# APPROVED MINUTES

## February 18, 2021 Standards Committee Meeting

RE: Minutes from the February 18, 2021 Standards Committee Meeting

## E 801-TCFO-02 MAINTENANCE OF TRAFFIC FOR MOVING OPERATIONS (WITH MARKUPS)

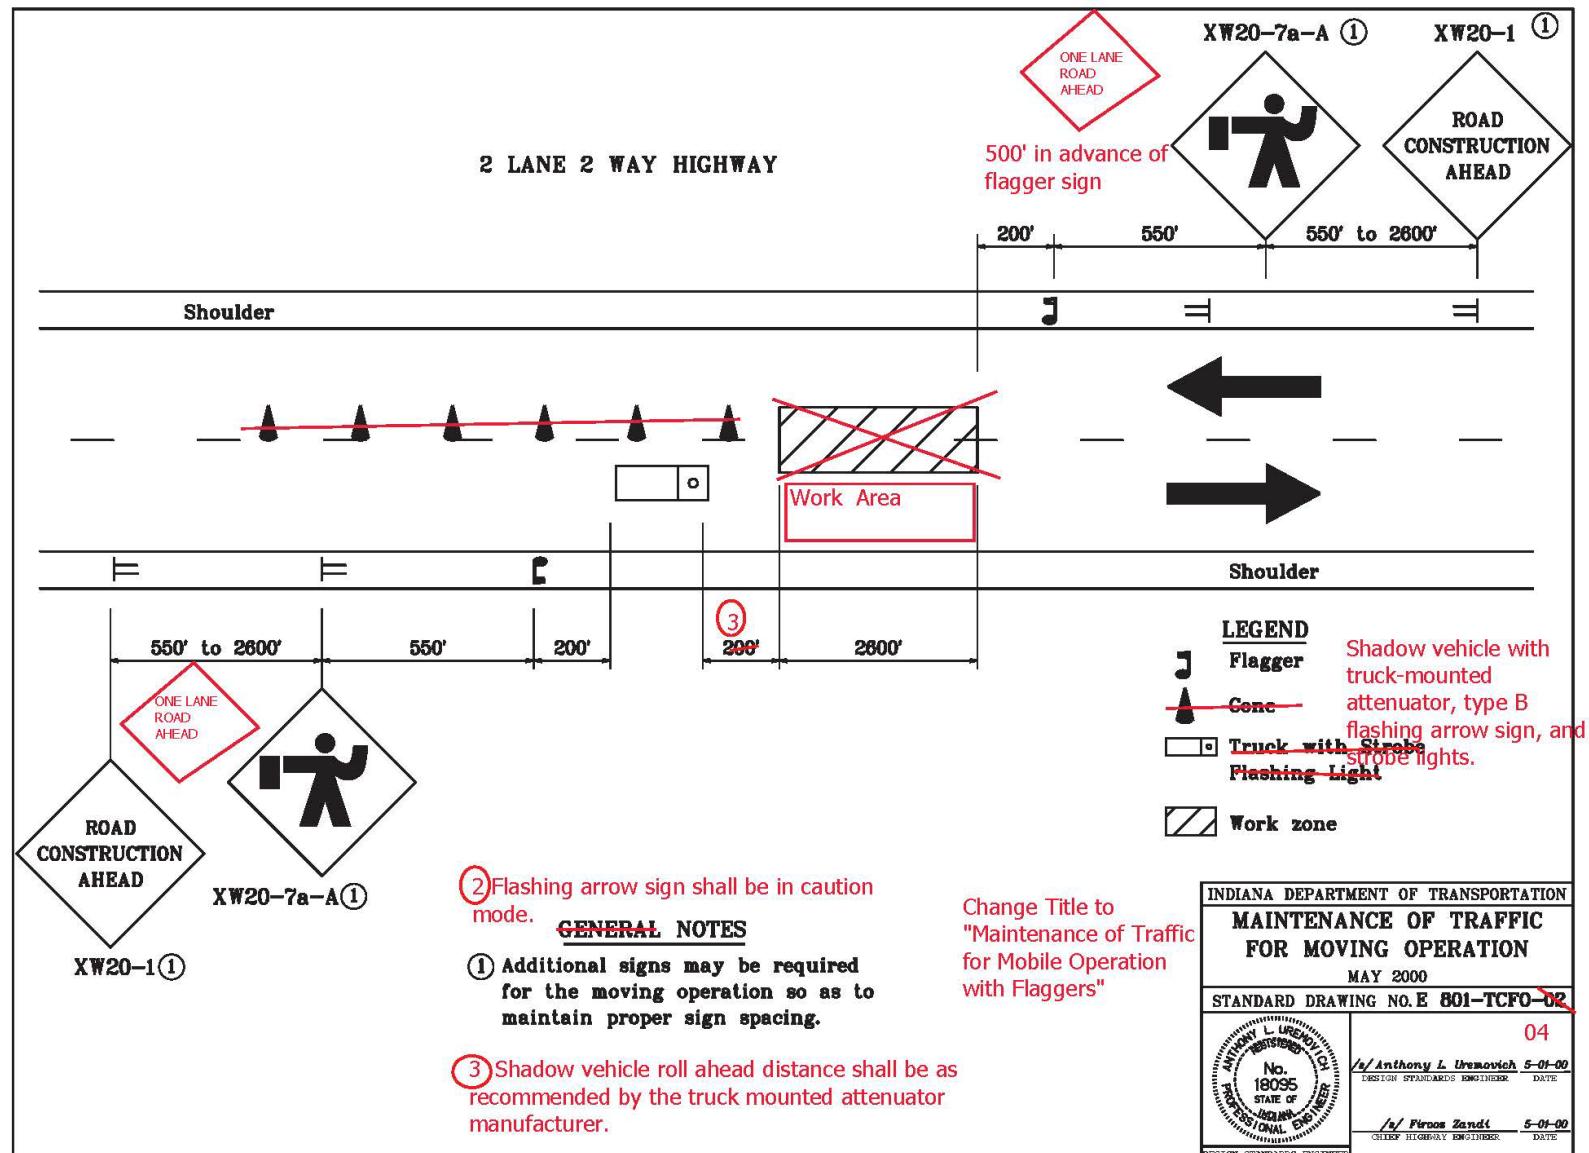
Add index sheet and simplified sheet for flagger operation on two lane road with speed &lt; 50 mph.

## E 801-TCFO-03 MAINTENANCE OF TRAFFIC FOR REFLECTOR REPLACEMENT (WITH MARKUPS)

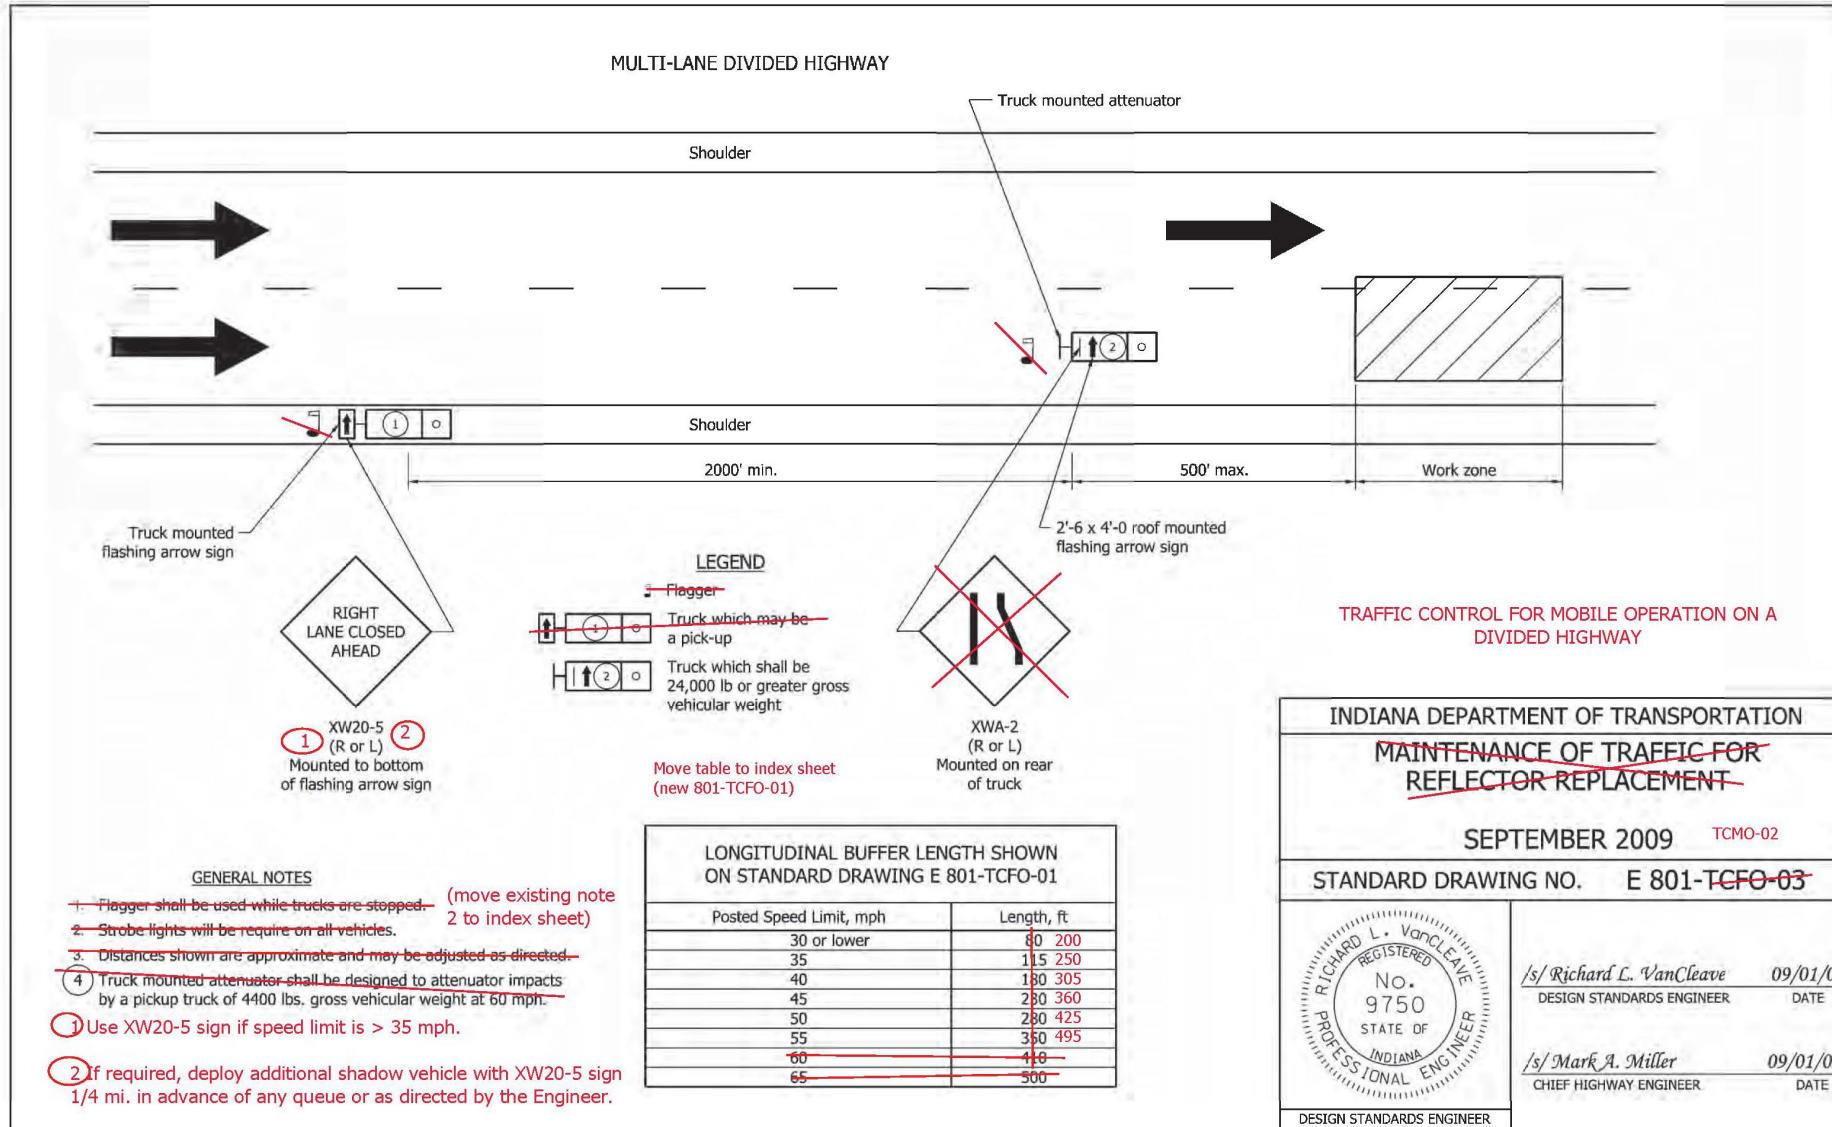
Create New Sheet for Flagging Operations < 50 mph similar to IMUTCD Figure 6H-10

## E 801-TCFO-05 TRAFFIC CONTROL FOR OVERHEAD INSTALLATION (WITH MARKUPS)

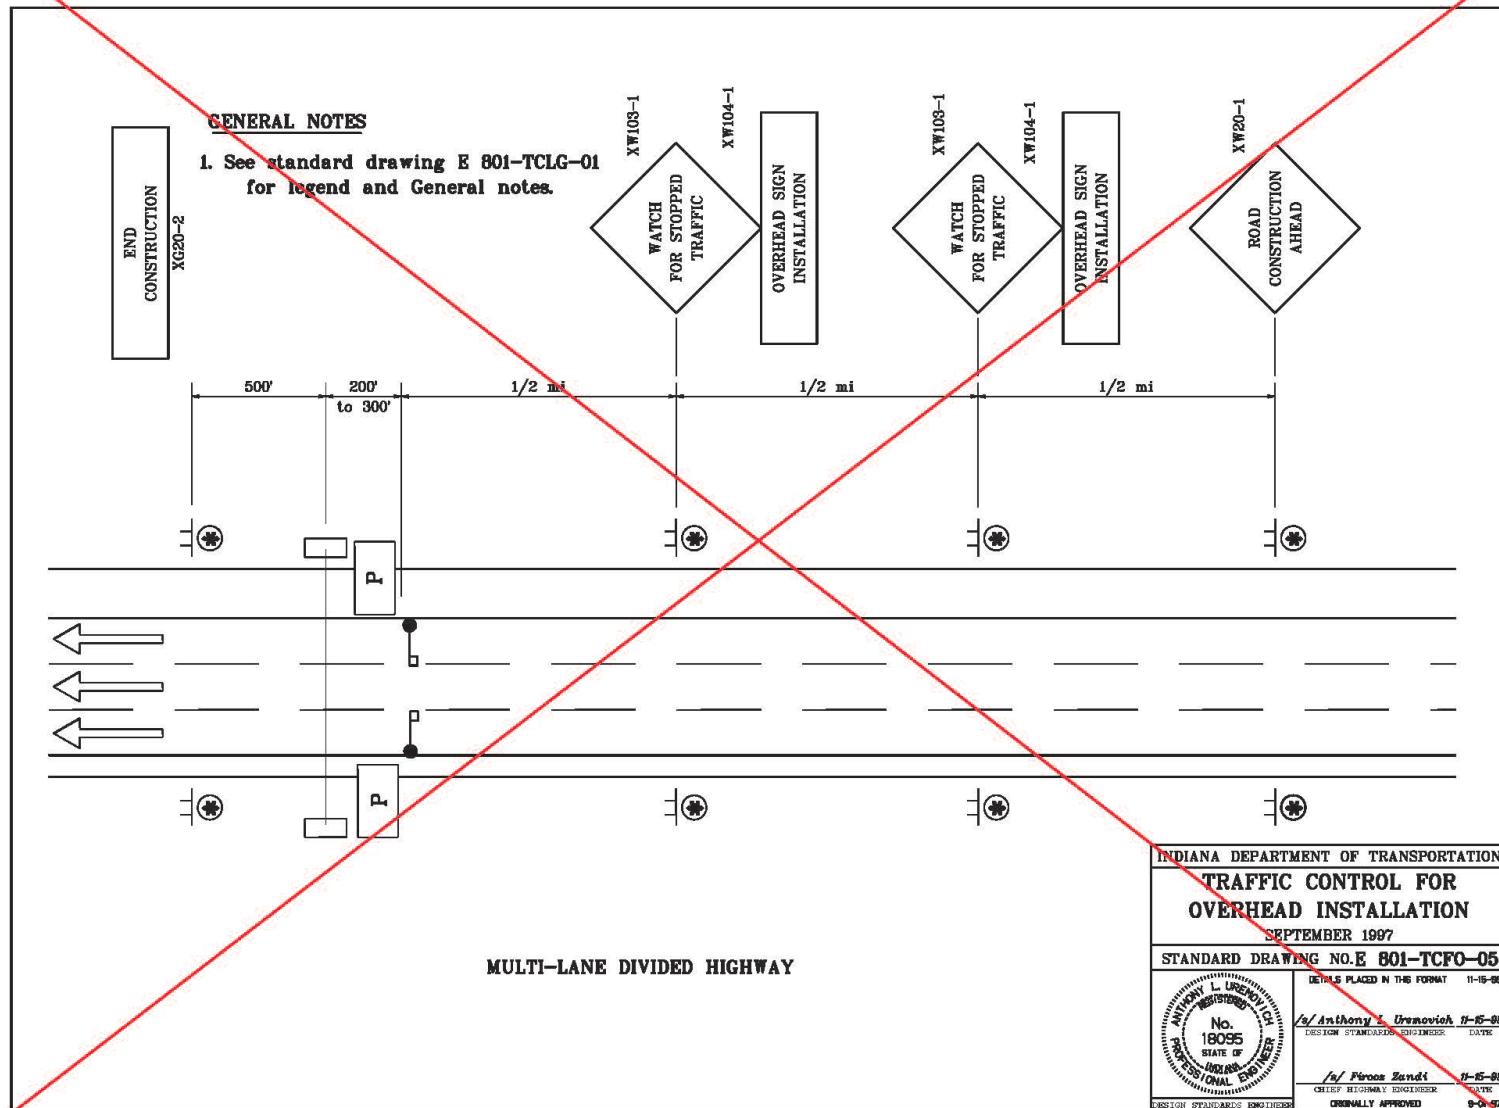
~~DELETE~~

E 801-TCTC-05 TRAFFIC CONTROL FOR DAYTIME LANE CLOSURE (WITH MARKUPS)

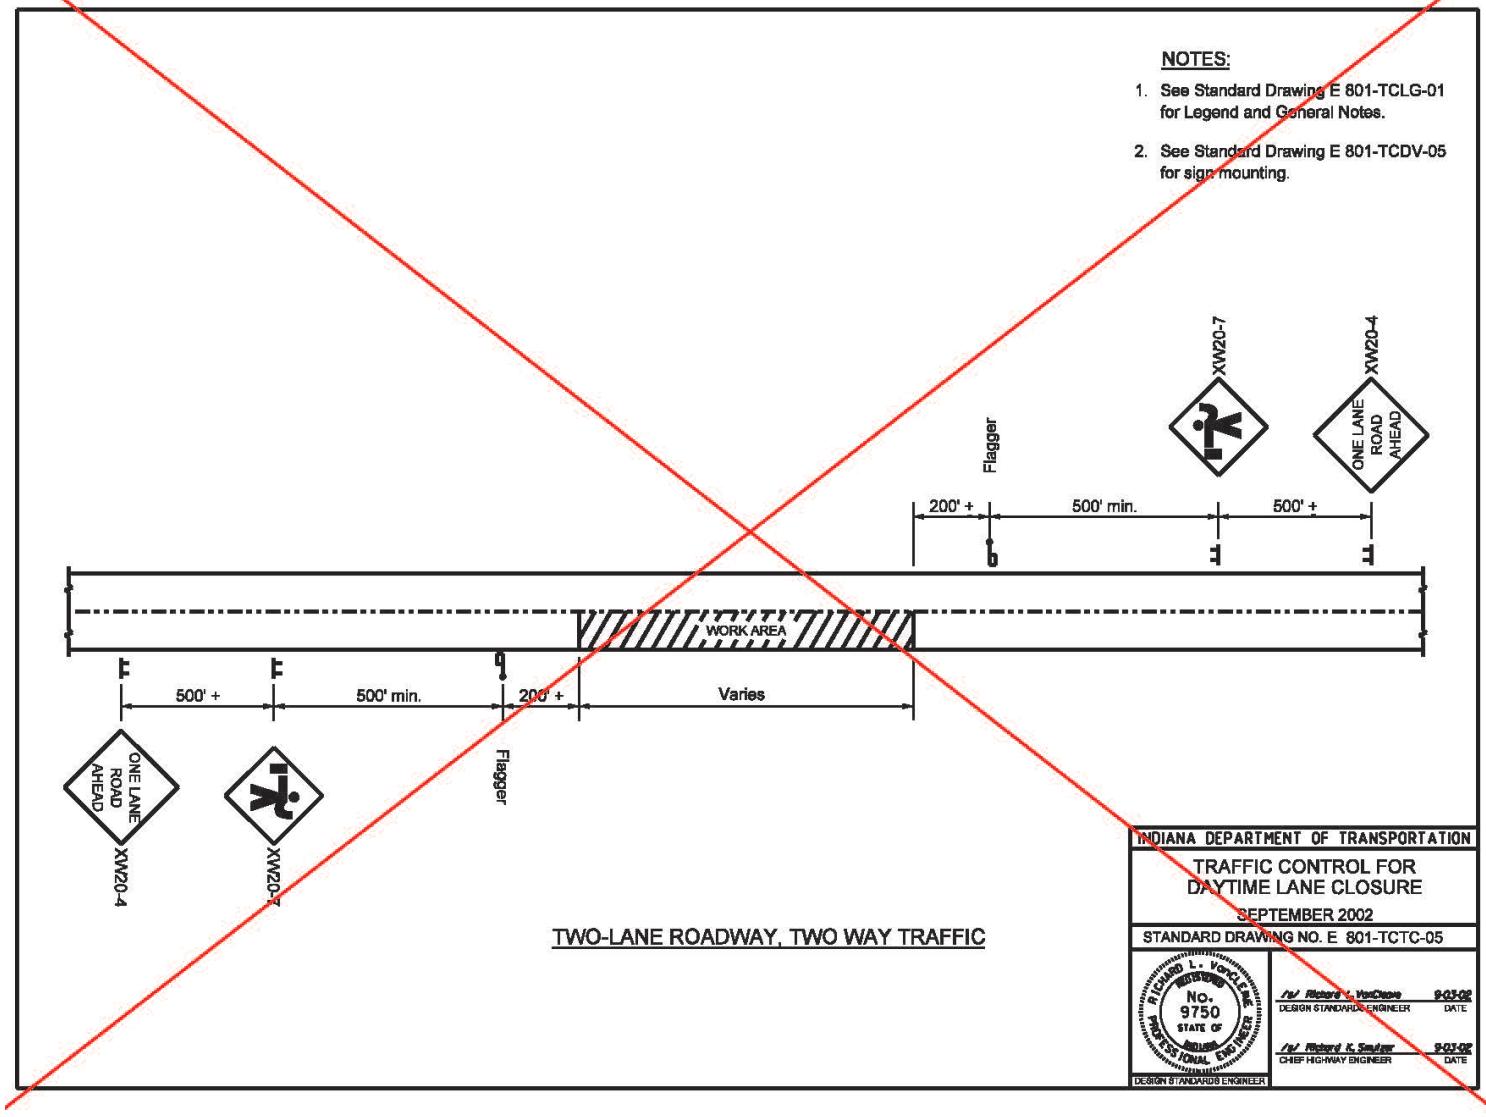
Delete (Addressed in 801-TCFO Series)

E 801-TCTC-06 MAINTENANCE OF TRAFFIC FOR RPM CASTING INSTALLATION (WITH MARKUPS)

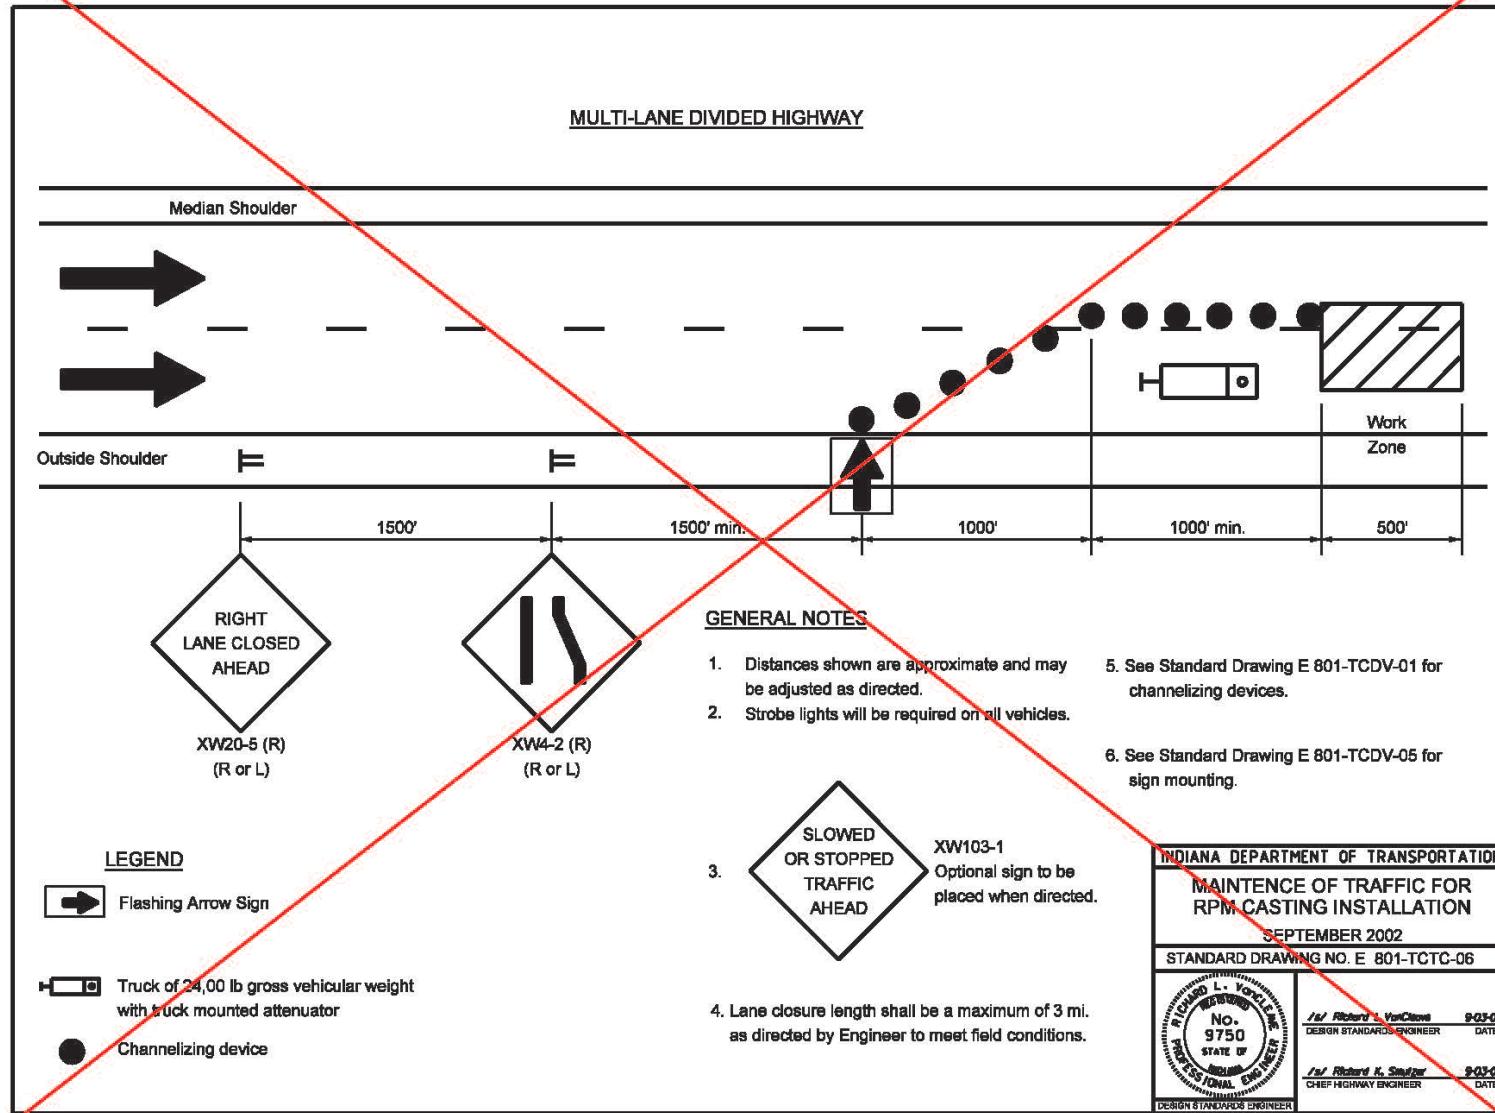
(Duplicate of Existing 801-TCFO-03 and Proposed 801-TCMO-02)

## E 801-TCTC-09 MAINTENANCE OF TRAFFIC FOR RPM REFLECTOR REPLACEMENT (WITH MARKUPS)

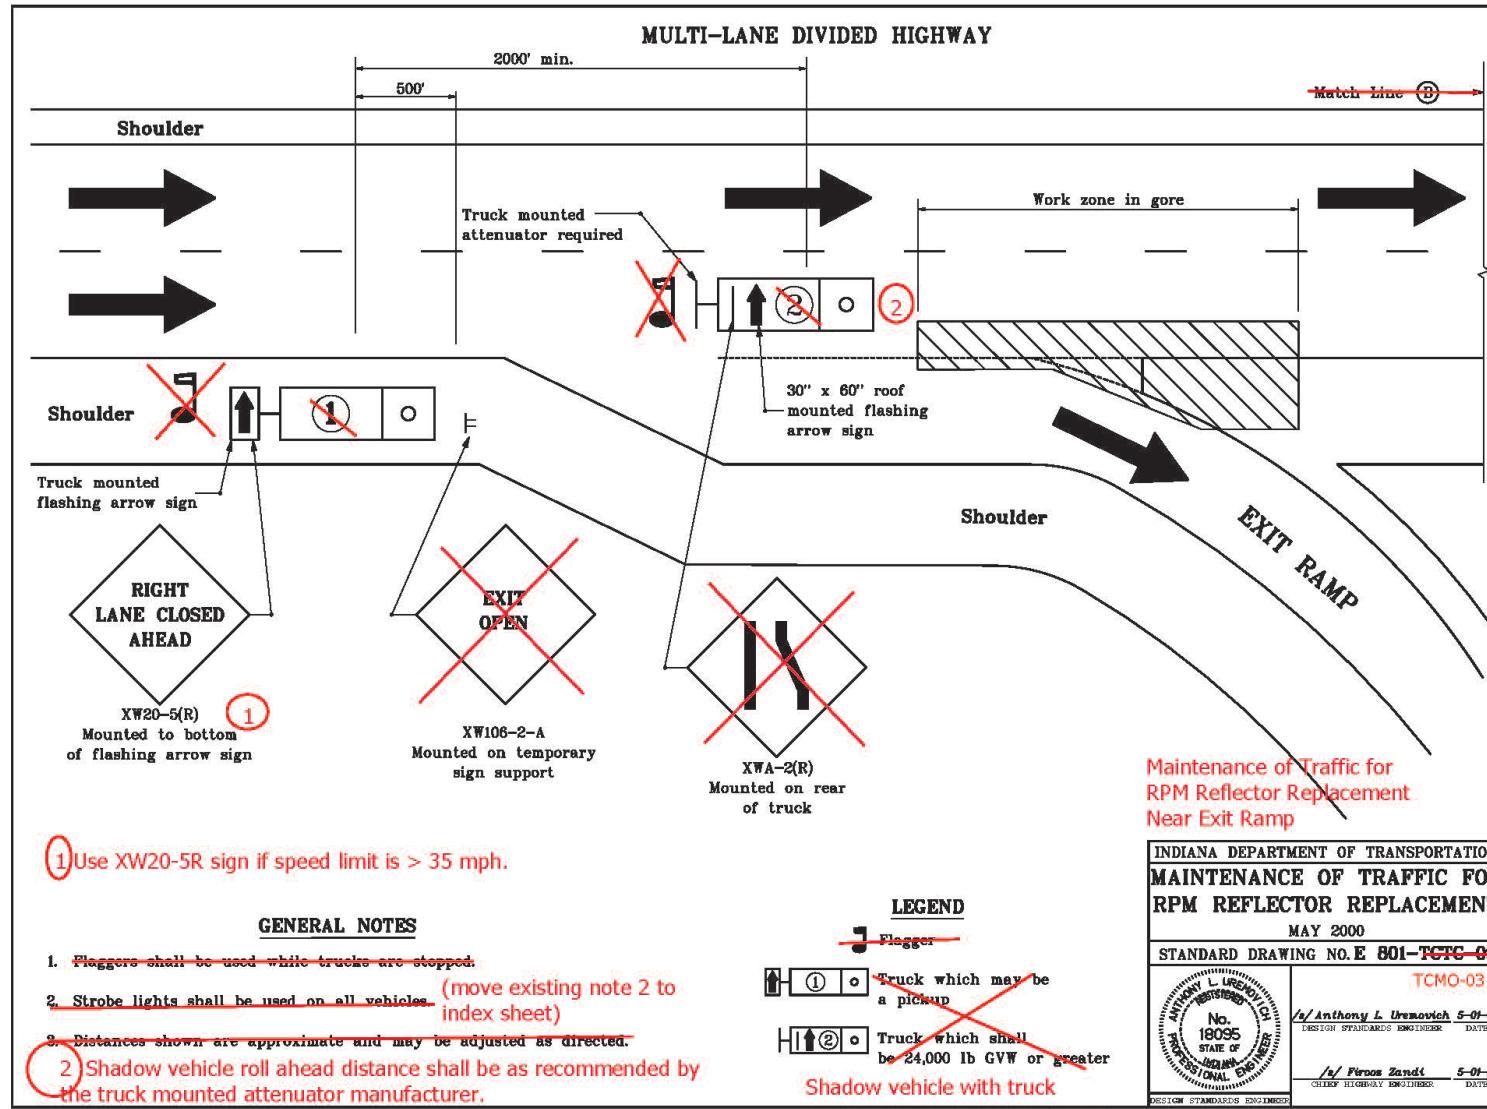
Move to New Series on Traffic Control for Mobile Operations
